# 9, 10 and 11 High Street, Dilhorne Addendum and Response to Conservation Comments

# 9, 10 and 11 High St, Dilhorne Addendum to Heritage Statement and Response to Conservation Comments

This Addendum was commissioned from Jenny Wetton Conservation in 2016 by Brendan Jordan and relates to an application for Listed Building Consent (ref. 2016/0068). Its purpose is to address comments from consultation with the Council's Listed Buildings, Conservation Areas, Non-Designated Heritage Assets, Design Section and relates to a Heritage Statement from May 2016 which should be read with this report.

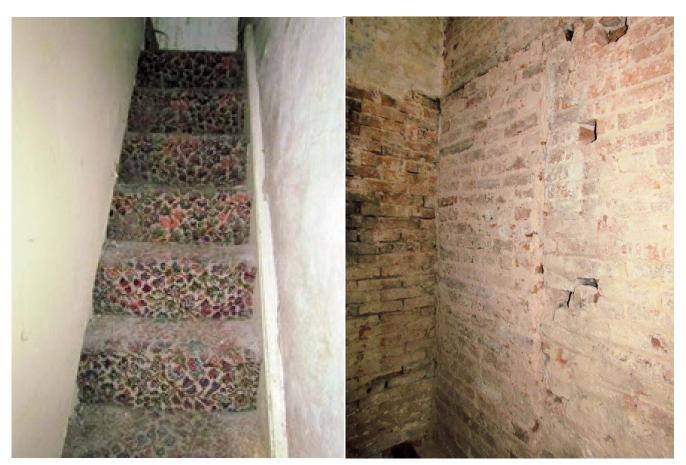
The Council found the Heritage Statement to be a useful document but thought that it appeared not to have been used to inform the changes proposed. The applicant's existing and proposed plans have been through a number of revisions and the heritage statement was prepared using an interim version. A further revised set of plans has now been submitted, also based on specialist advice, which show kitchen and bathrooms.

The applicant intends to occupy the 1980s extension while work is underway and will make a future, separate application for replacement windows in this part and for the moving of the well. Once the refurbishment work is complete, the extension will be demolished.
